UNITED STATES PATENT AND TRADEMARK OFFICE

APPLICATION NO.	FILING DATE	FIRST NAMED INVENTOR	ATTORNEY DOCKET NO.	CONFIRMATION NO.
10/695,806	10/30/2003	Dale A. Trsar	66396-093	6880
7590 06/20/2005				
McDERMOTT, WILL & EMERY 600 13th Street, N.W. Washington, DC 20005-3096				
			EXAMINER ASSOUAD, PATRICK J	
			ART UNIT 2857	PAPER NUMBER
DATE MAILED: 06/20/2005

Office Action Summary	Application No. 10/695,806	Applicant(s) TRSAR ET AL.	
	Examiner Patrick J. Assouad	Art Unit 2857

DETAILED ACTION

Fig. 2.

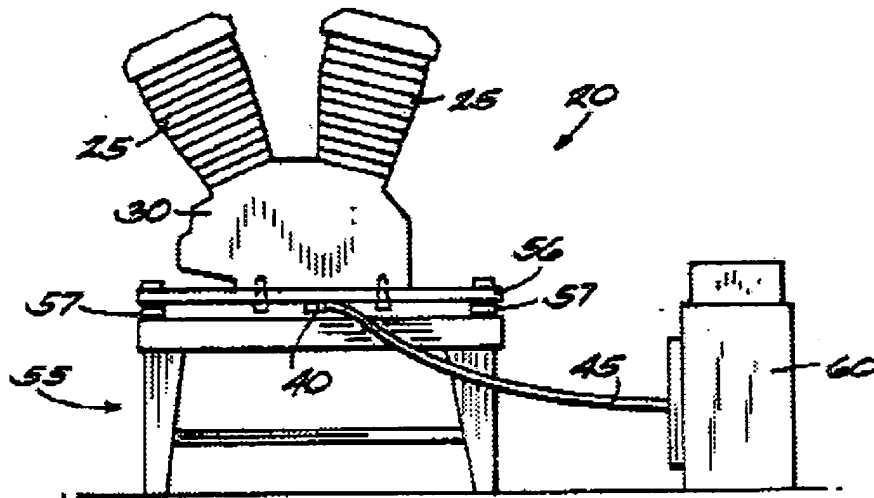
5. Applicant is referred to at least Fig. 2 of Liang et al. (reproduced below) and to the following paragraphs from Liang et al.:

6. First, the sensor 40 of Liang et al. may be directly associated with the displacement measurement sensor of Applicant. Second, engine blocks of automobiles like in Applicant's Fig. 1 are nearly always attached to the bodies of automobiles with rubber mounts (not shown by Applicant) much like the rubber isolators 57 of Liang et al. Thus, Applicant's body-side mount 125 connected to cowl 130 is directly associated with the test stand 55 of Liang et al. The test stand 55 of Liang et al. is a fixed or stationary structure in the same way that the body-side mount 125 of Applicant's Fig. 1 is fixed or stationary; i.e. fixed or stationary via rubber mounts or rubber isolators connected between the engine block and the automobile body. Therefore, the sensor 40 of Liang et al. clearly measures the claimed displacement of the engine cylinder block movement relative to a stationary structure or relative to a fixed position.

Fig. 4

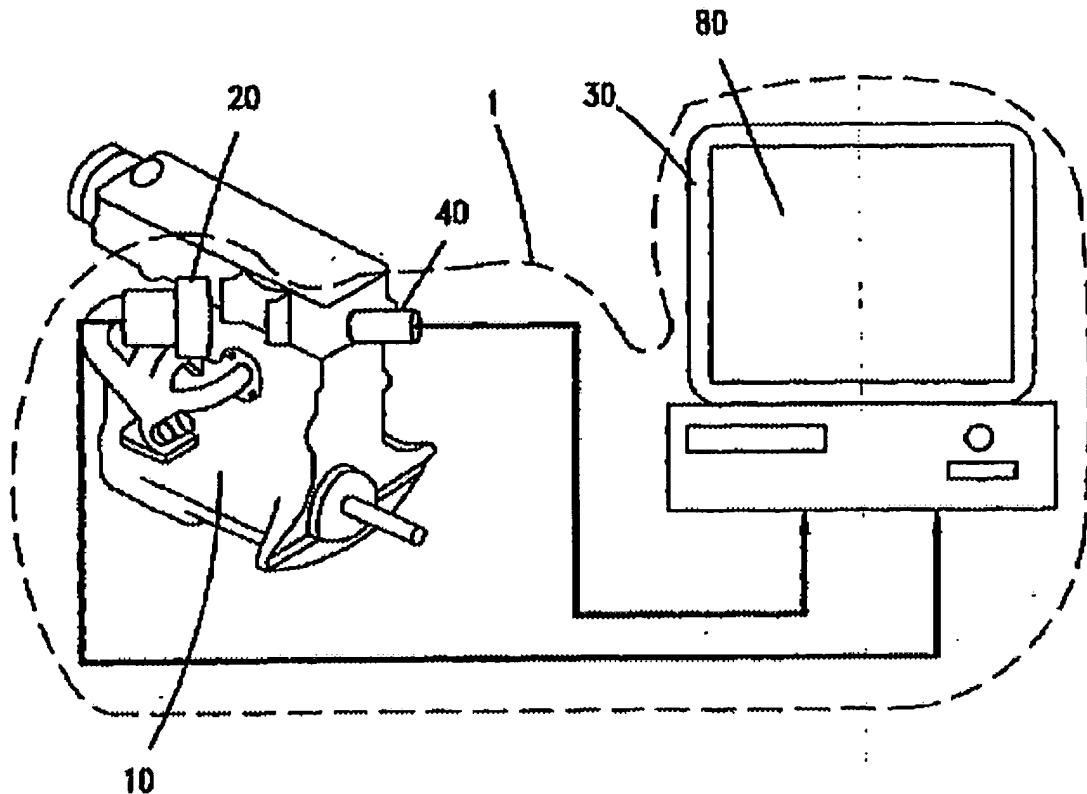
Fig. 4 of DeBotton et al. is reproduced below.

11. The association between the instant claimed invention (independent claims 1,17, and 27) and DeBotton et al. is as follows: as per the claimed displacement measurement device or means for monitoring engine block movement, see the vibration sensor (20) mounted to the engine block (10) of Fig. 4 of DeBotton et al.; as per the claimed signal analyzer or means...for evaluating engine block movement, see the computer (30) of Fig. 4; as per the evaluation of engine cylinder contribution or evaluation of engine block movement, see at least the FFT vibration processing, vibration signature analysis, reference data base construction and comparison

12. Note that vibration is a known function of displacement/acceleration of engine block (10) and that the vibration sensor (20) of DeBotton et al. may be a "transducer such as an accelerometer, velocity transducer, optical or laser based vibration transducer...being held in place with any suitable, temporary fixing means such as magnets or straps..." (para. 0142)

Fig. 2.

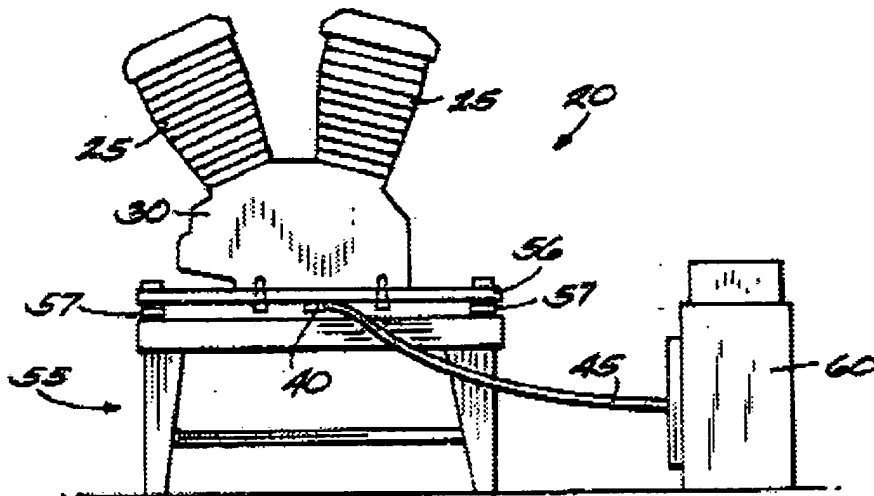
Fig. 2 of Liang et al. is reproduced below.

16. From Fig. 2 (above) and its description, we clearly see vibration (acceleration/displacement) measurements “relative to a stationary structure” which is the test bed 56 and/or test stand 55 of Liang et al.

17. Thus, it would have been obvious to one having ordinary skill in the art at the time the invention was made to combine the “detection of engine block movement relative to a stationary structure” teaching of Liang et al. with the “universal diagnostic method and system for engines” of DeBotton et al. because such a combination provides accurate and reliable (vibration/acceleration/displacement) measurements for diagnostic purposes, and for fine-tuning an engine by accurately balancing all cylinder contributions relative to a fixed position or stationary structure.
